DETAILED ACTION

This is a non-final Office Action for application number 10 737,048 BRACKET ASSEMBLY filed on 12/16/03. Claims are pending. This non-final Action is in response to the BPAI decision dated 9/24/08. The text of those sections of Title 35, U.S. Code not included in this action can be found in a prior Office action.

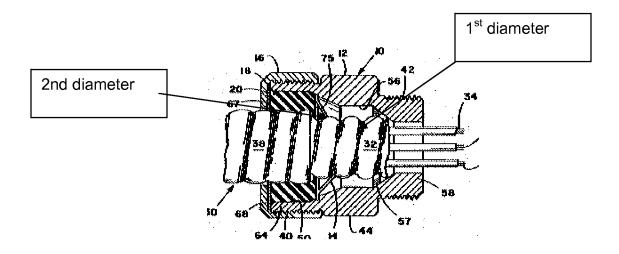
The patent to Bolante et al. teaches an assemblage having a an electrical connector (30) having a metal body (See Abstract) with a tubular projection having a push-through portion having a first diameter (smaller part of 32, See marked drawing below) and an engaging portion having a second diameter (larger part of 32, See drawing) larger than the first diameter; and a metal support (14) having a major part that is substantially rigid and includes an aperture formed by a plurality of deflectable spokes (62), which diverge away from the plane of the major part of the support, the aperture having a center opening with a third diameter greater than the first diameter and less than the second diameter, whereby the tubular projection push-through portion slides through the aperture and the spokes engage the second diameter of the engaging portion and mount the electrical connector with the support, wherein a stop (38) associated with the second diameter limits the amount of movement possible for the support.
